F.A.I. RTE.	SECTION	COUNTY	TOTAL SHEETS	SHEET NO.
94		COOK	916	333
STA. 190+65 (NB I-57) TO STA. 2316+00 (NB RYAN)				
FED. ROAD DIST. NO. ILLINOIS FED. AID PROJECT				
• (1516, 1717, & 1818) R-4 62304

ILLINOIS DEPARTMENT OF TRANSPORTATION
 F.A.I. 94 (DAN RYAN EXPRESSWAY)
 DRAINAGE AND UTILITY PLAN
 NB I-94 (DAN RYAN EXPRESSWAY)
 NB I-94 STA. 2241+00.00 TO 2247+00.00

ADDENDUM 1 - NSW 05/08/06

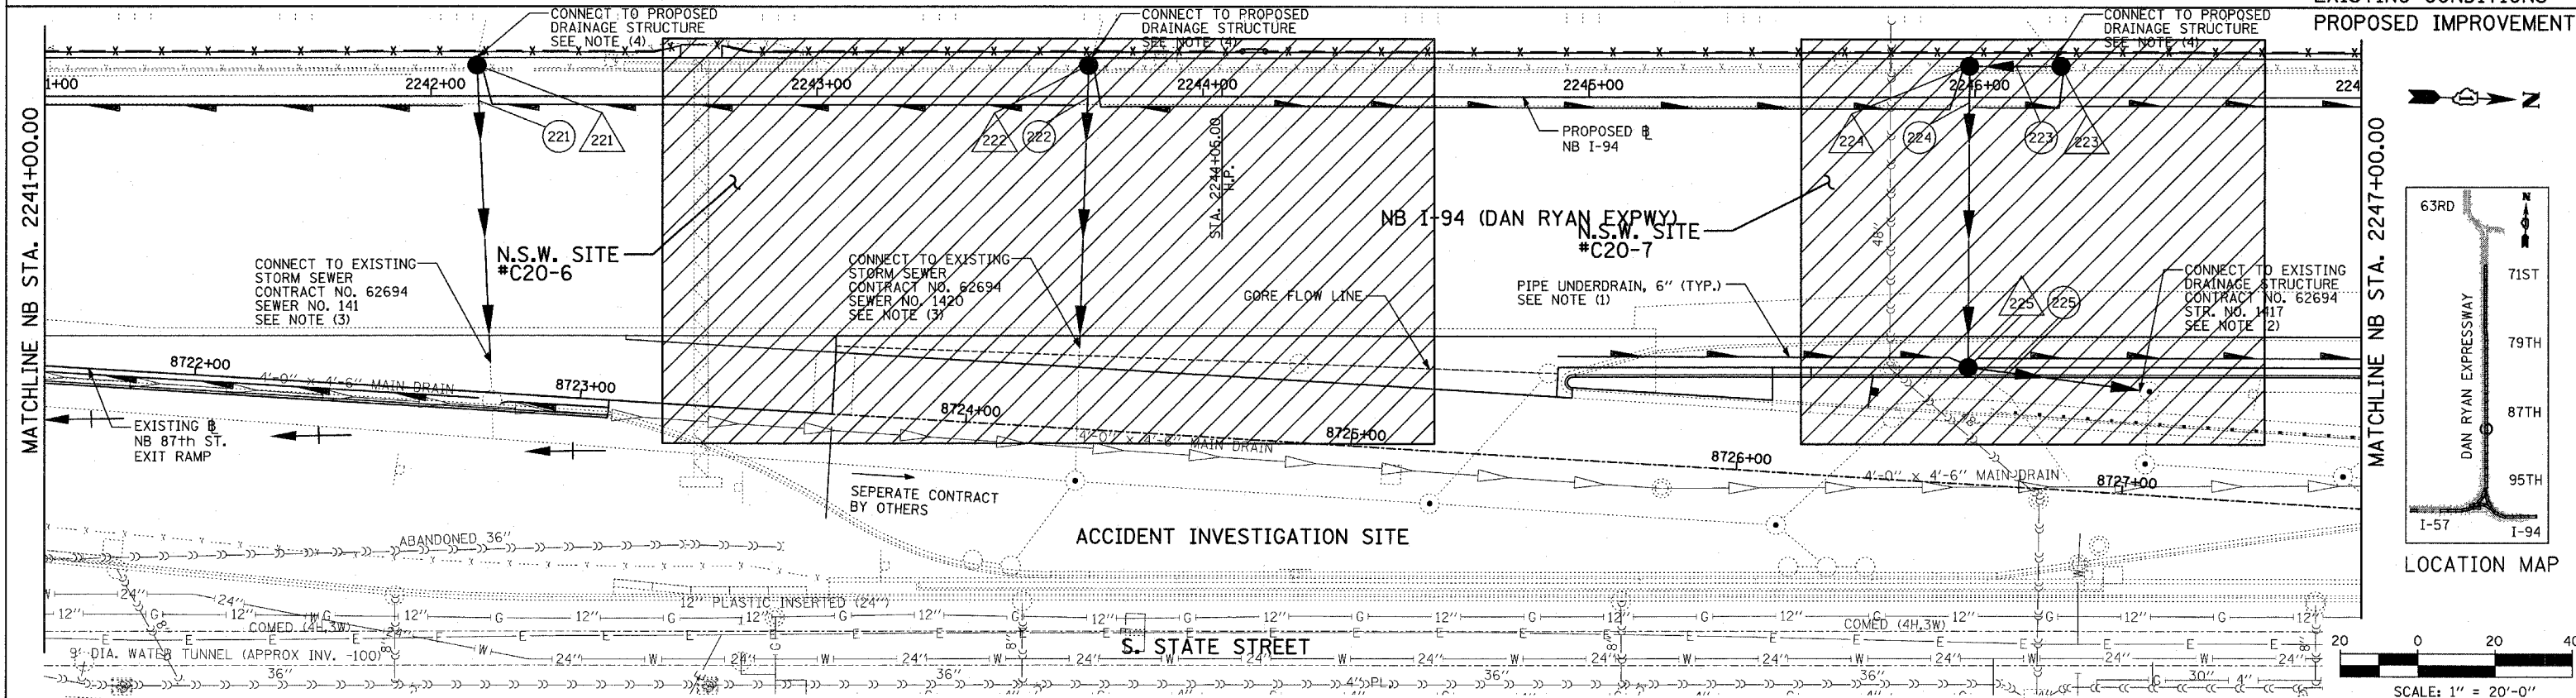
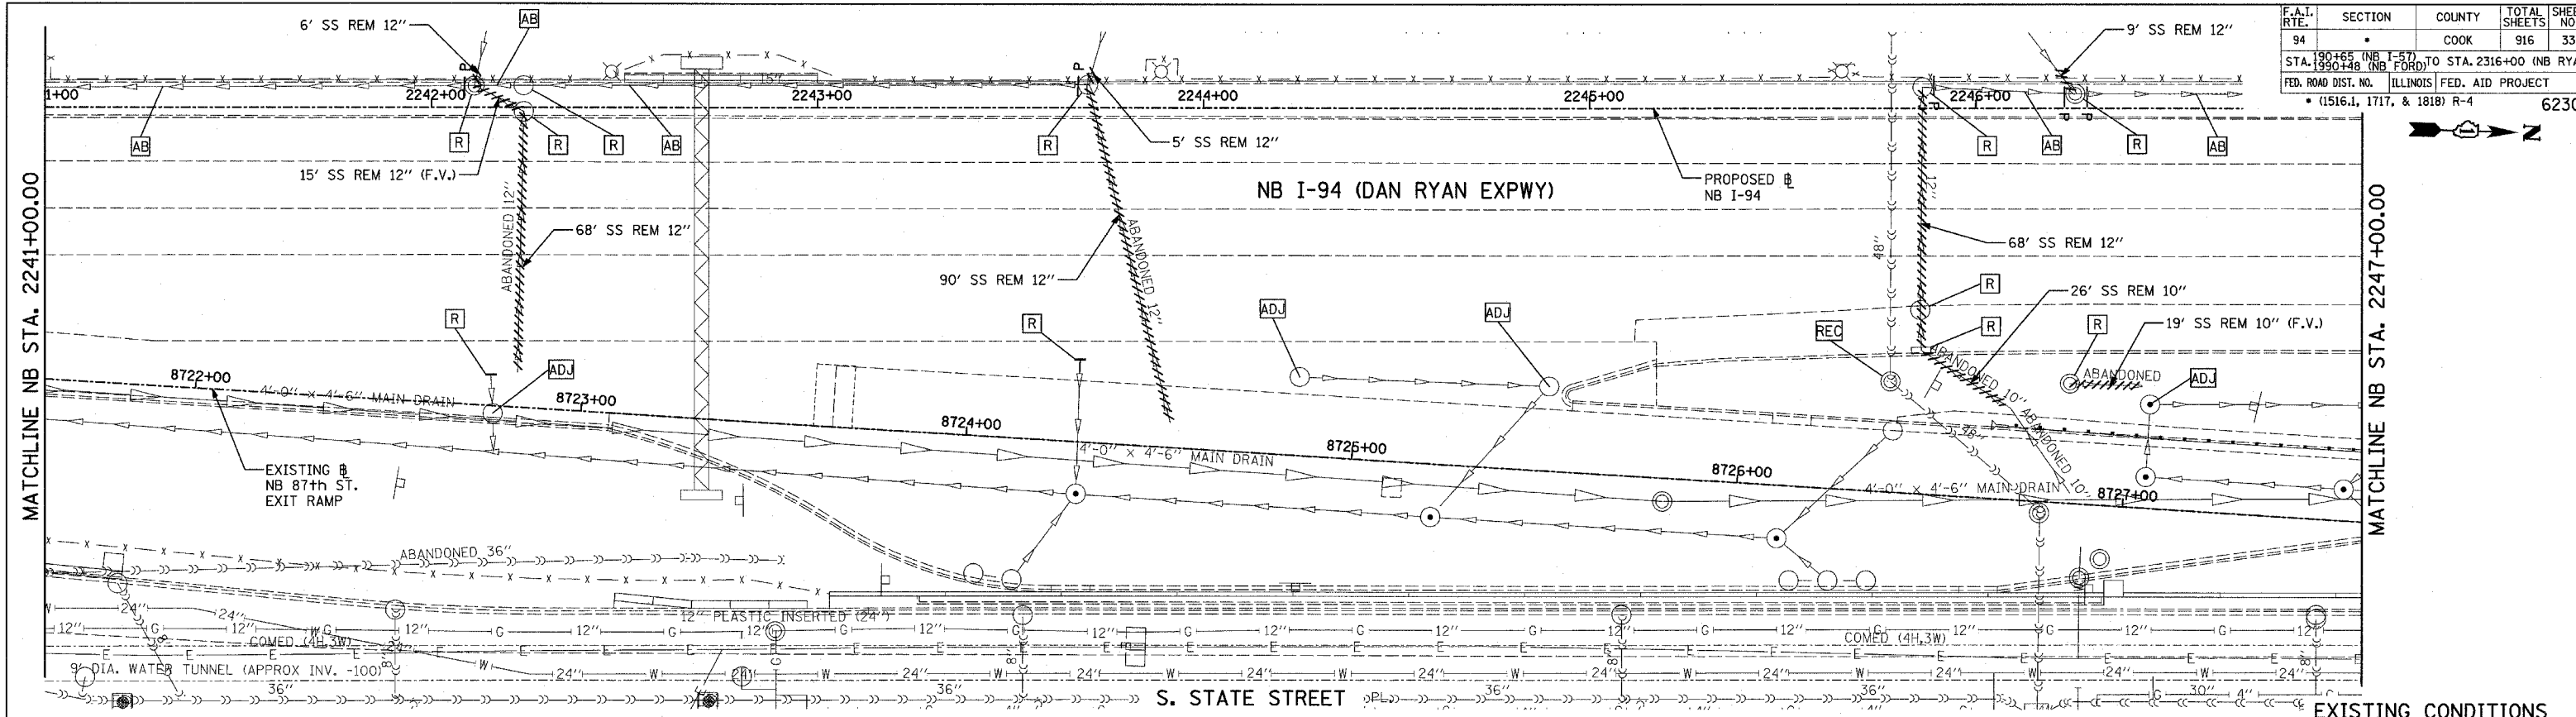
NSW - NON SPECIAL WASTE SITES ADDED TO SHEET
